Wisconsin Electric POWER COMPANY
231 N. MICHIGAN, P.O. BOX 2746, MILWAUKEE, WI 53201

September 16, 1981

DOCKET NOS. 50-266 AND 50-301
ADDITIONAL INFORMATION
AUXILIARY FEEDWATER SYSTEM
POINT BEACH NUCLEAR PLANT, UNITS 1 AND 2

Figure II.E.1.2 - AFW Flow

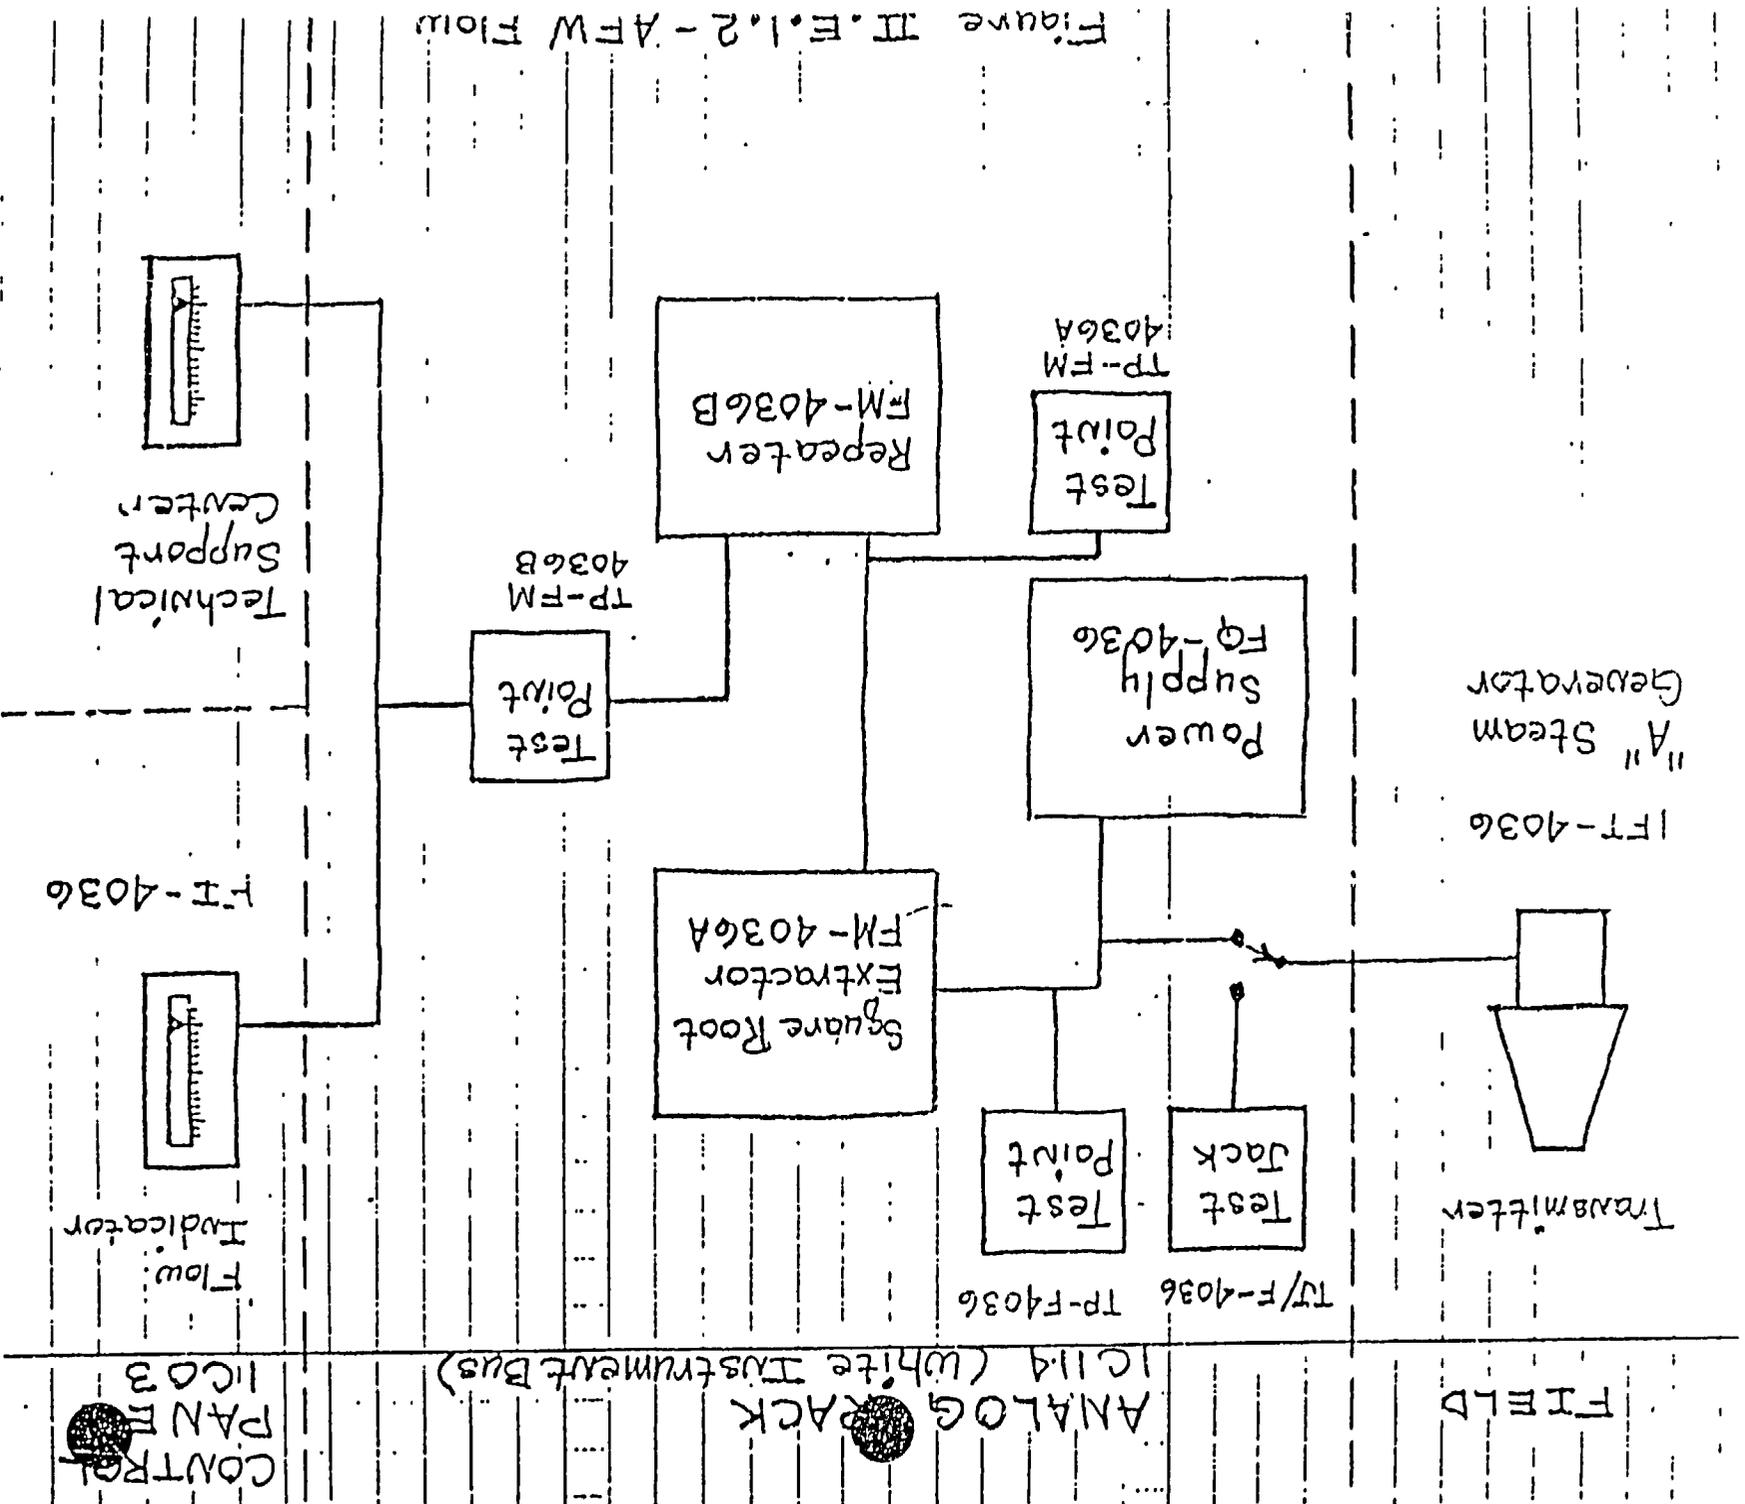
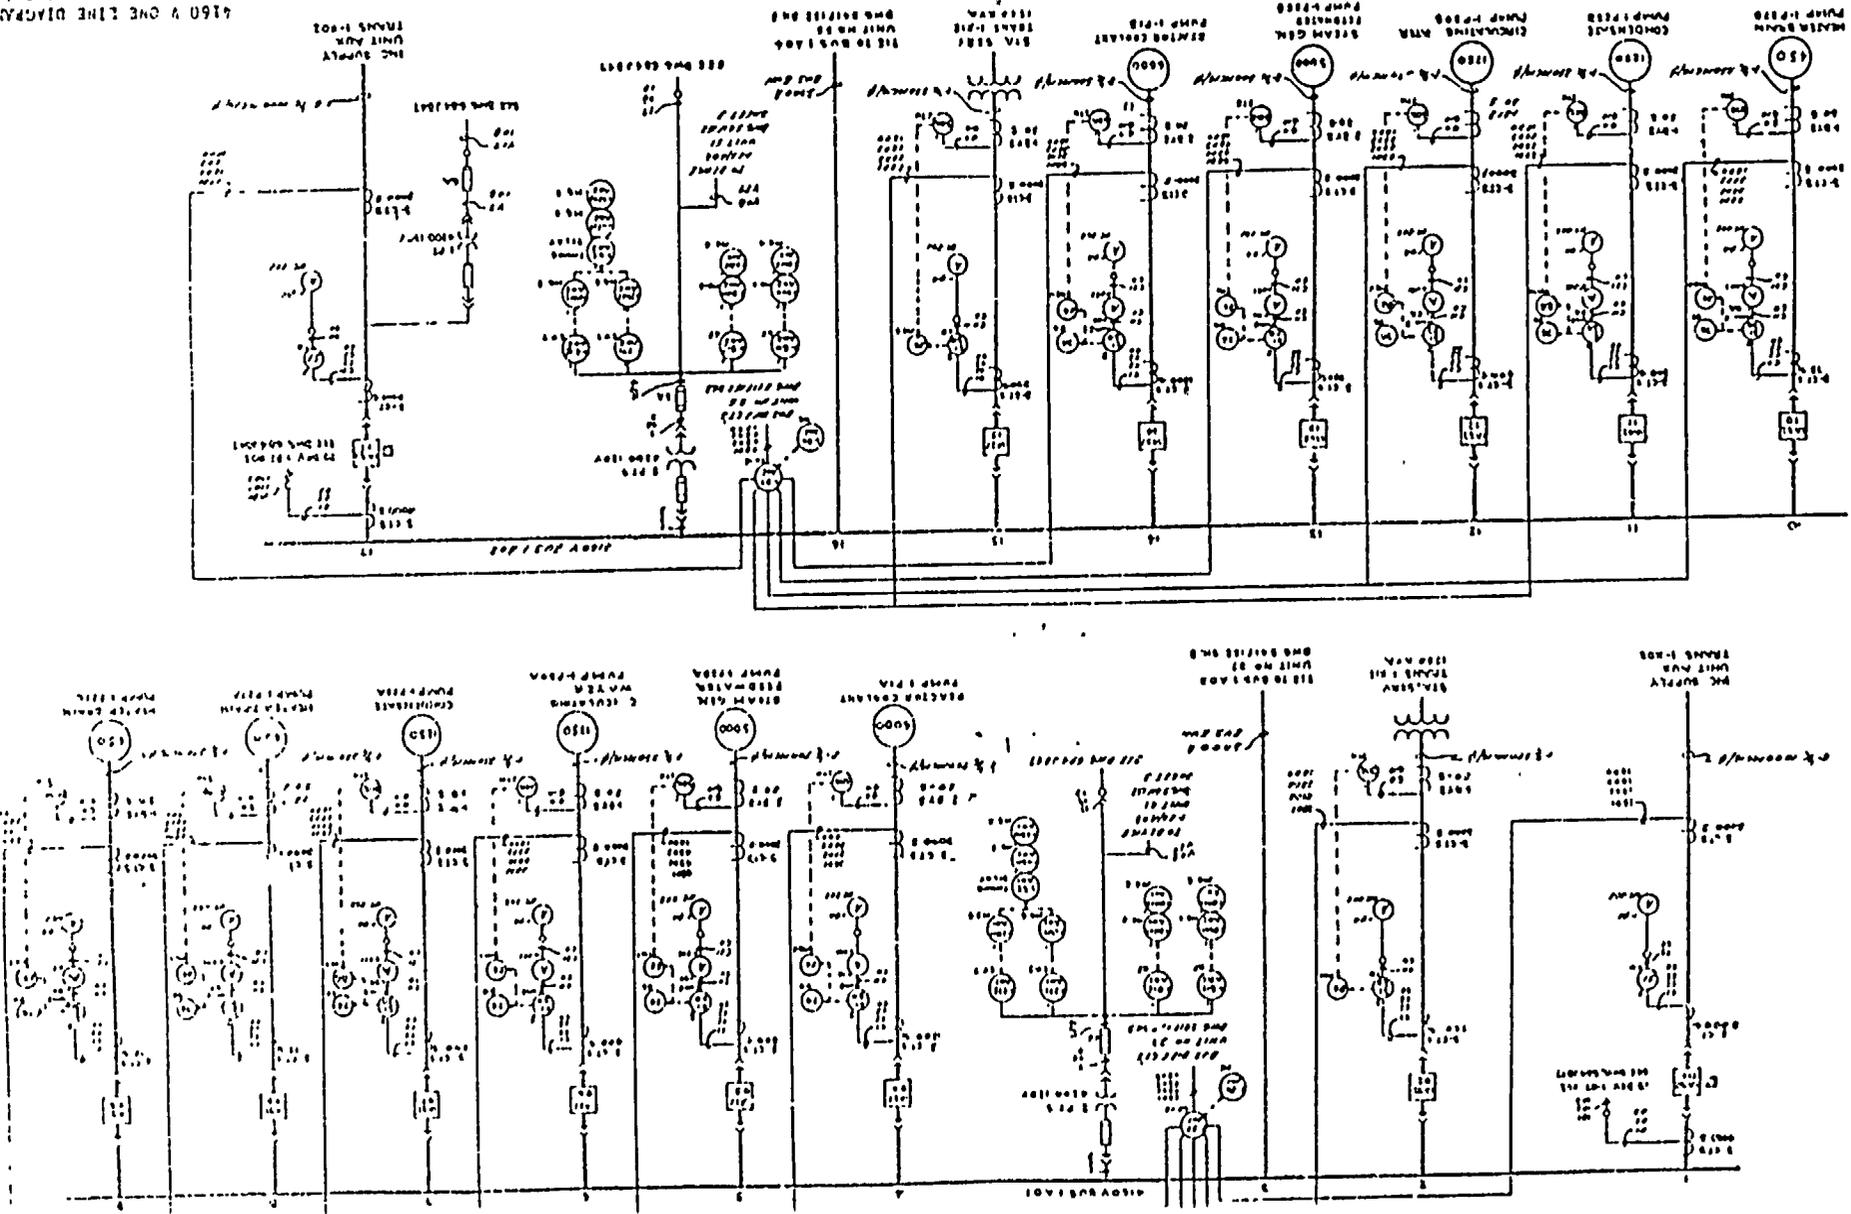
4. Describe the AFW flow channels at Point Beach. This description should include:
- a) The specific source (vital bus) from which each channel is powered.
 - b) Capability for testing and calibration including interval between tests. Indicate whether this testing is required by the Point Beach Units 1 and 2 Technical Specifications.
 - c) The specific indication available in the control room for each channel.

RESPONSE: The Point Beach Nuclear Plant now has two levels of direct AFW flow indication available in the control room. AFW pump discharge flow indication is available for each pump. This flow channel was described in detail at item 2.1.7.b of our March 14, 1980 letter. A schematic of these channels, including the specific power sources, was provided with our December 31, 1979 letter. We have also recently completed the installation of flow indicators for AFW flow to each steam generator. These channels consist of four flow transmitters, one for each steam generator, with readouts in the control room. These flow channels are powered by the white or yellow vital instrument bus. A schematic of this AFW flow channel is attached. Channel check and calibration frequencies for the AFW flow channels were included in item 36 of Table 15.4.1-1 of our proposed Technical Specification changes submitted with our letter to the NRC dated February 4, 1981. Specific indications for each flow channel available in the control room consists of analog meters for each channel with a range of 0-300 gpm for the direct to steam generator flow, 0-200 gpm for the motor-driven AFW pump flow and 0-400 gpm for the steam-driven AFW pump flow.

4160 V ONE LINE DIAGRAM
FIGURE 8.2-4

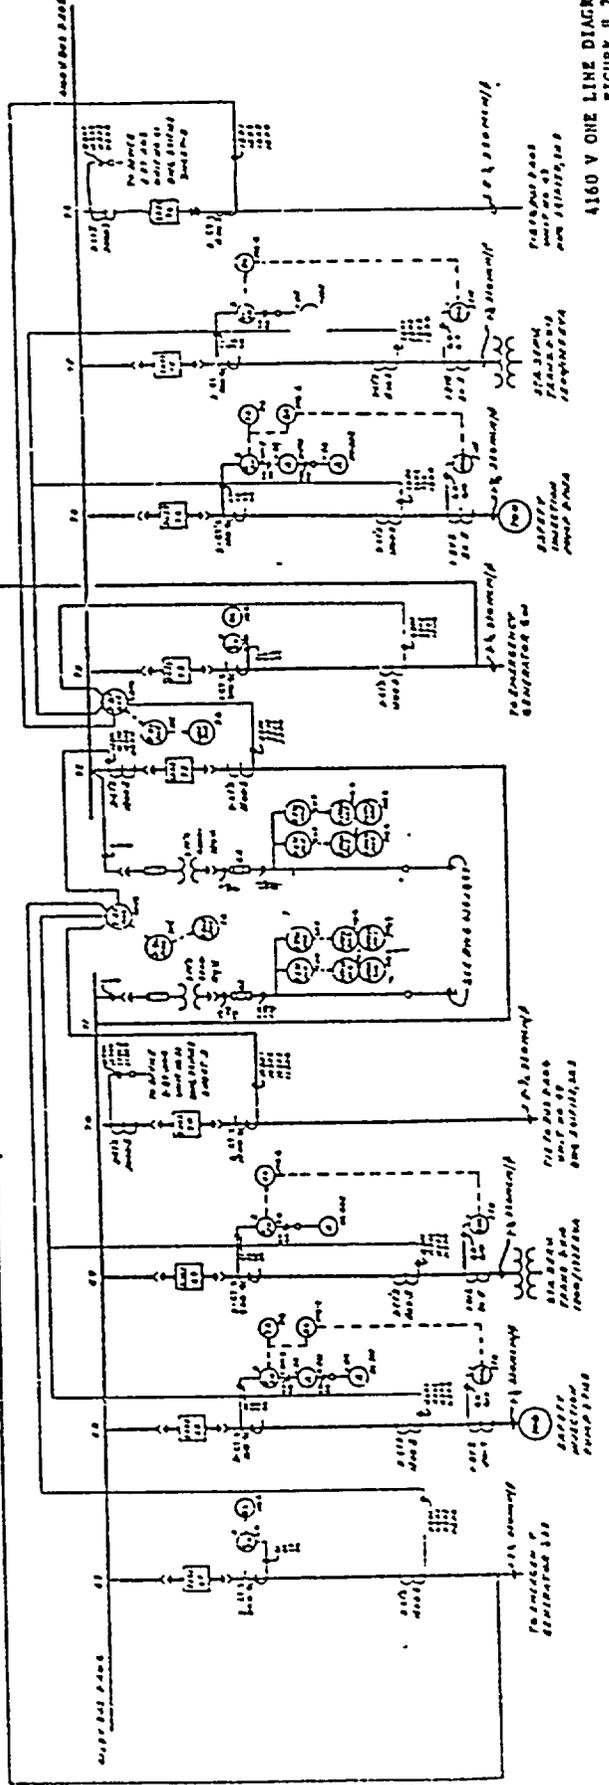
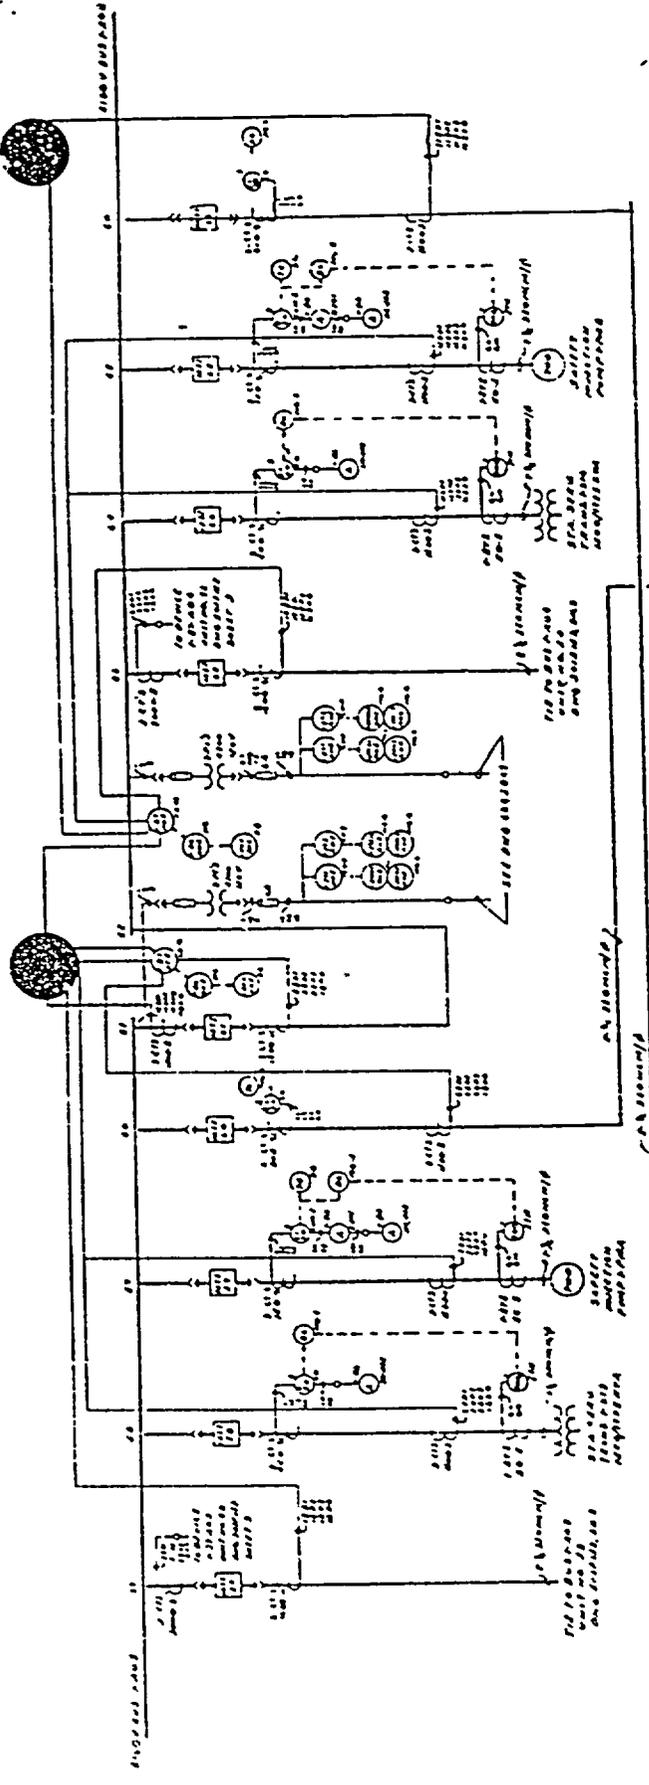
5. Provide electrical one-line diagrams for 4160V AC, 480V AC, 120V AC and 125V DC.

RESPONSE: Electrical one-line diagrams are provided in Chapter Eight of the PFDGAR. For your convenience, we have reproduced these figures and enclosed them with
